<p align="center">CDM: Recommendation Form for Small Scale Methodologies (version 01)</p> <p align="center"><i>(To be used for presenting questions/proposals/amendments to the simplified methodologies for small-scale CDM project activity categories)</i></p>
Date of SSC WG meeting:	24–27 February 2009, SSC WG 19
Title/Subject (give a small title or specify the subject of your submission, maximum 200 characters):	Applicability of AMS-I.C to cogeneration projects displacing grid electricity and surplus electricity exporting to the grid
Indicative methodology to which your submission relates (refer the items of Appendix B of the Simplified Modalities and Procedures), if applicable.	AMS-I.C version 13
Name of the authors of the query:	Nikolaus Wohlgemuth Institution: First Climate (Switzerland) AG Nikolaus.Wohlgemuth@firstclimate.com luca.morganti@firstclimate.com
Summary of the query:	
Please use the space below to summarize the query related to SSC methodologies/categories SSC Modalities and Procedures provide recommendation/analysis of the SSC WG.

SSC-Submission number	SSC_273
Date when the form was received at UNFCCC secretariat	27 February 2009
Date of transmission to the EB	27 Fe

Schematic of the baseline and project activity

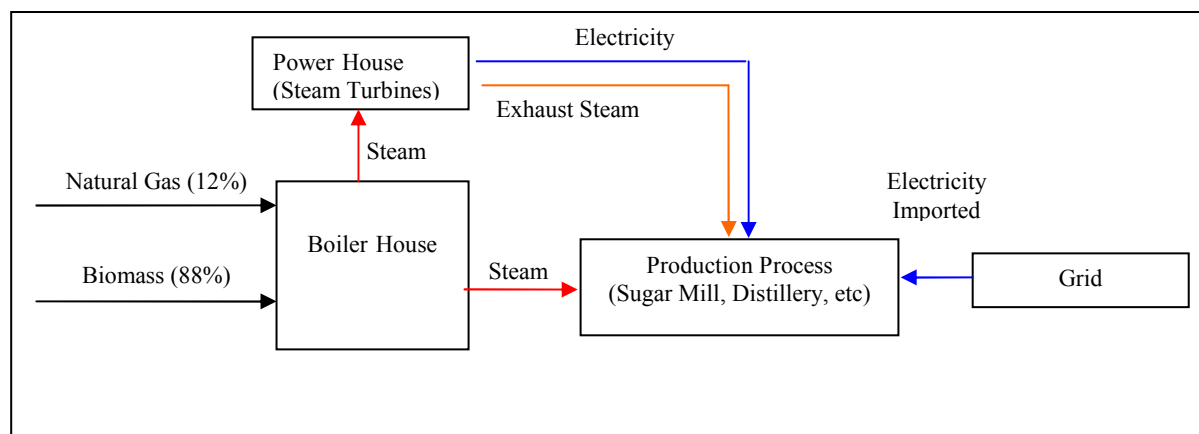
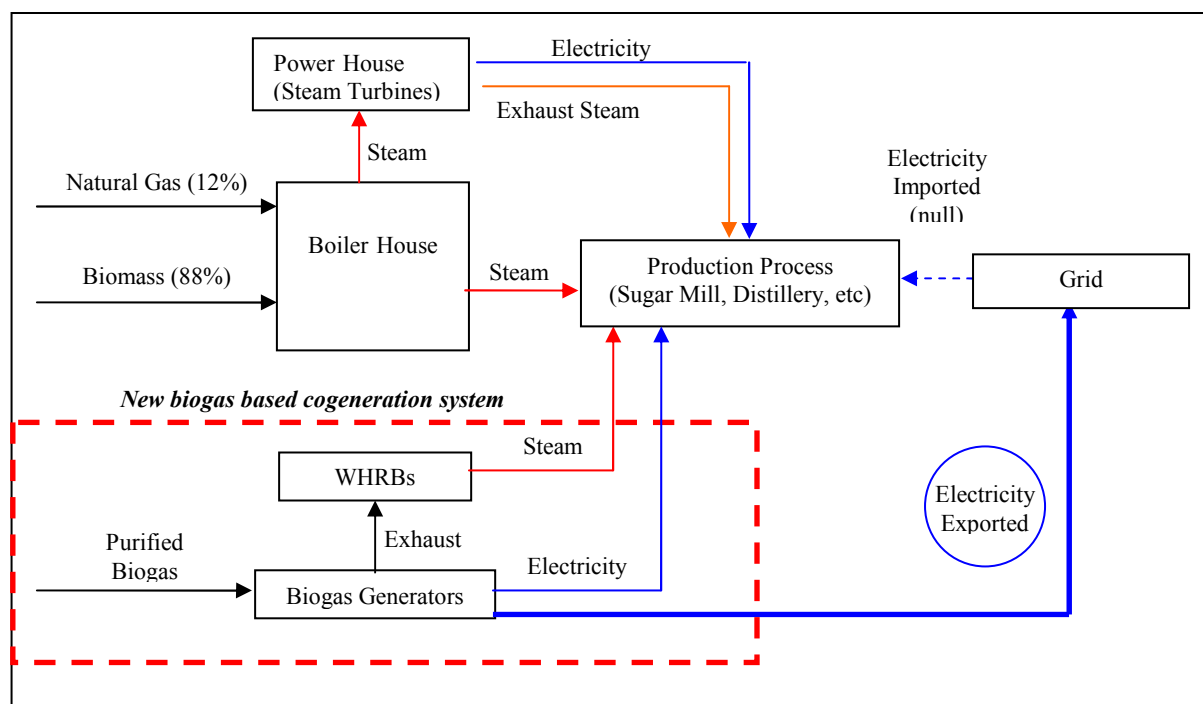
<p>Original text from PP:</p> <p>The project activity involves generation of electricity and heat through the installation of a new biogas-based cogeneration system consisting of biogas generators and waste heat recovery boilers. It will be running side-by-side with an existing co-fired (biomass and natural gas, supplying 88% and 12% of the energy intake, respectively) cogeneration system comprising boilers and steam turbines. The existing cogeneration system caters steam and power needs of a mill producing sugar, ethanol and paperboard. The mill also imports electricity from the grid.</p> <p>The electricity generated by the project activity will fully displace the electricity imported from the grid, while it will not displace the electricity generated by the existing cogeneration system as this will continue working as per historical conditions (to cater the heat and power demands of the mill). Surplus electricity from the project activity will be exported to the grid. Emission reductions shall be claimed only for the net electricity exported to the grid.</p> <p>It is understood from the clarification SSC_174 that AMS I.C ver. 13 is applicable to the biogas-based cogeneration systems exporting surplus electricity to the grid. The most appropriate baseline scenario for the aforementioned project activity is provided in paragraph 7, option (e) which states:</p> <p><i>“Electricity is imported from the grid and/or produced in an on-site captive power plant (with a possibility of export to the grid); steam/heat is produced from renewable biomass.”</i></p> <p>Further, it is explained in the footnote to paragraph (7), option (e) that:</p> <p><i>“Baseline biomass consumption may include a small amount of complementary fossil fuel as under this scenario, no emission reduction can accrue on account of heat generation.”</i></p> <p>Therefore, our first question is:</p> <ol style="list-style-type: none"> 1. Can a natural gas energy share of 12 % qualify as “small amount of complementary fossil fuel consumption”?

Secondly, what we comprehend from the compound conjunction “AND/OR” used in 7(e) is that cogeneration projects can either displace electricity imported from the grid, or produced in on-site captive power plant, or both of them, and export surplus electricity to the grid.

Paragraph 11 provides a procedure to calculate baseline emissions taking into account both the grid and the captive power plant emissions factors. However, it does not provide any guidance for the determination of the baseline emission factor in the case where the electricity generated by the project activity displaces only the electricity imported from the grid, and does not displace the captive electricity generated by an existing cogeneration system which continues to run side-by-side with the project cogeneration system.

2. Can the Project Proponent claim emission reductions from exporting electricity to the grid by using only the grid emission factor? (i.e. net electricity exported to the grid x grid Emission Factor)

The SSC WG agreed to recommend a revision of AMS-I.C as contained in annex 2 of the SSCWG 19 meeting report. The proposed revision eliminated the possible restriction from the interpretation of what is a "small amount of complimentary fuel". The revision of AMS-I.C also includes additional baseline scenarios and results in expanded applicability of the methodology for biomass based heat and/or power generation project activities (including cogeneration) that supply: (a) electricity to a grid and/or displace grid electricity or both; (b) electricity and/or thermal energy for on-site consumption or for consumption by other facilities and combination of (a) and (b).

If the revisions are approved by the Board, the project proponent may evaluate if the proposed project activity is covered by the revised version.
